ATTACHMENT A Remarks

ATTACHMENT D Amendments to the Drawings

Serial No.: 10/529,394 Confirmation No.: 6724

Fig. 1 PRIOR ART

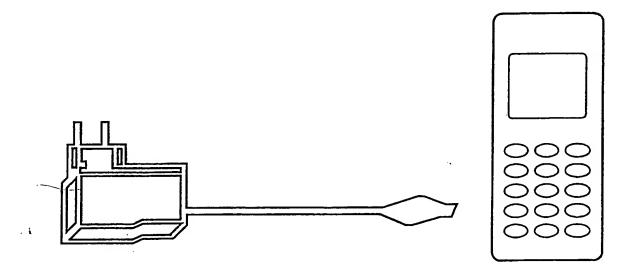
Figure 1 has been objected to "because it requires a prior art label, since only what is already known is shown." Figure 1 has been amended to include the label "PRIOR ART" as required.

in Figure 1, the label PRIOR ART has been added.
